07-486r0 SAS-2 Receiver Device Physical Testing

To: T10 Technical Committee

From: Kevin Witt (Kevin.witt@maxim-ic.com) & Mahbubul Bari

Subject: 07-486r0 SAS-2 Receiver Device Physical Testing

Figure 126 -- SAS-2 Stressed Receiver Sensitivity Test Block Diagram

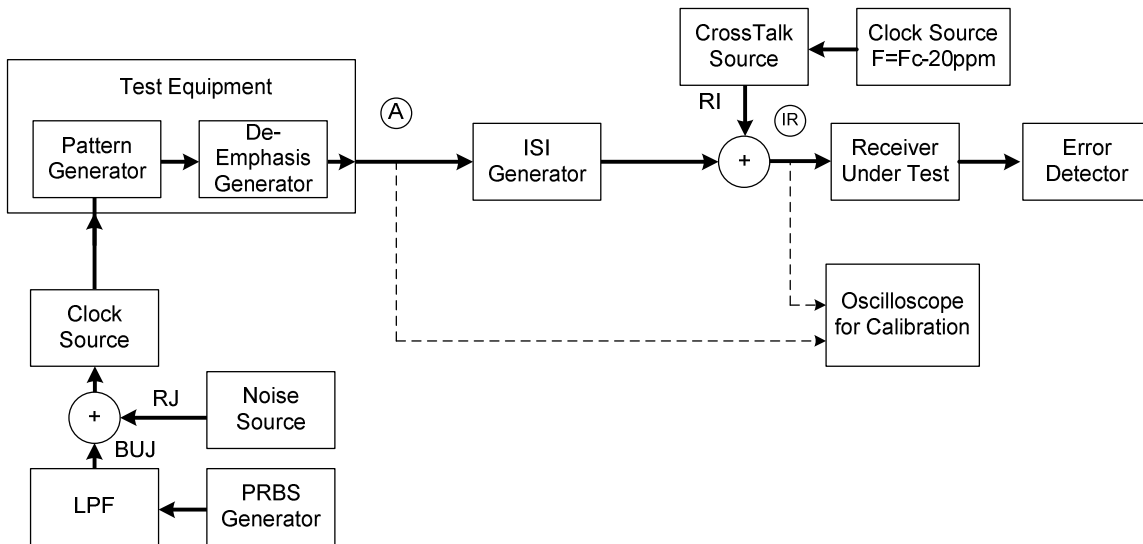
Replace section 5.3.7.4.4 in 07-339r6 with this text.

The following test shall be applied at the receiver device compliance point (IR or CR) as a means to perform physical validation of predicted performance of the receiver. Figure 126 shows the block diagram of the stressed receiver sensitivity test.

The design under test will demonstrate its ability to compensate for channel Inter Symbol Interference (ISI) representative of the SAS-2 reference channel while subjected to the budgeted jitter and cross talk sources.

As illustrated in the Figure 126, test equipment is used to generate a representative transmitted waveform (A) with the electrical characteristics of Table 73.

Figure 127 -- SAS-2 Reference Channel Differential Insertion Loss

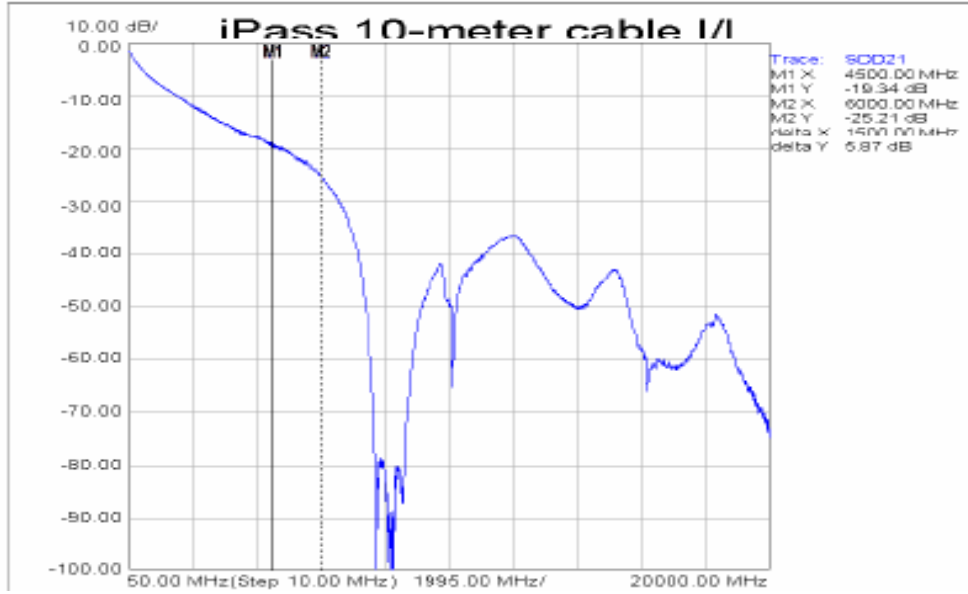
Per T10-07-193 the SAS-2 reference channel's differential insertion loss is illustrated below and leads to a nominal ISI generators insertion loss requirement of -15dB at Fbaud/2. The insertion loss is measured by observing the delivered eye opening at CR and IR per the specification in Table 73. This is calibration is illustrated in Figure 128.

Figure 129 -- Reference Channel Delivered Pulse Response

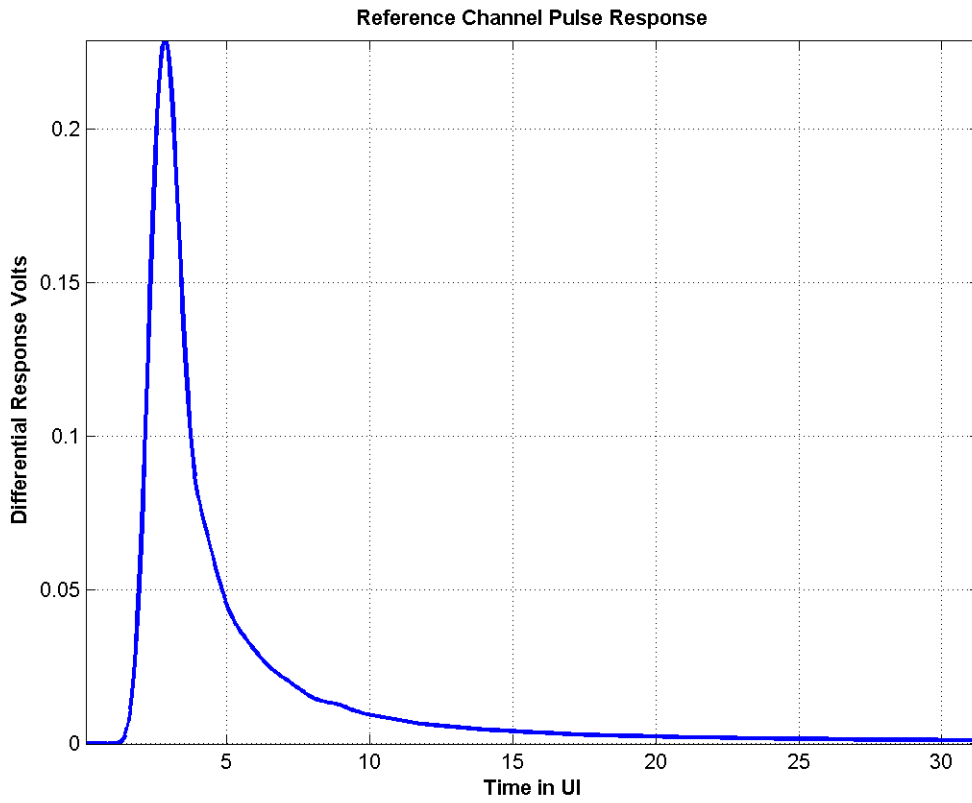
A representative delivered pulse response for this channel when driven with a transmit source (per Table 73) is illustrated in Figure 129 and Table 74.

Figure 130 -- Jitter Tolerance Test Configuration

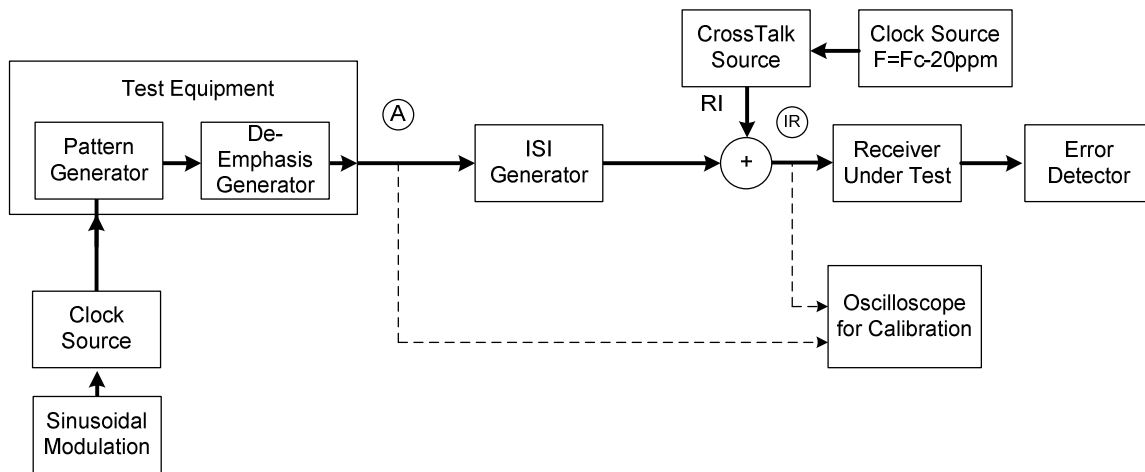
A compliant SAS-2 receiver shall satisfy the Jitter tolerance test described in this section. The jitter tolerance test leverages the receiver device physical test hardware. The receiver under test must demonstrate a BER of better than 1×10^{-12} with a 95% confidence level when subjected to the sinusoidal jitter of Figure 117. The Jitter tolerance test uses the electrical characteristics of Table 73 with the Transmitter RJ and BUJ jitter minimized.
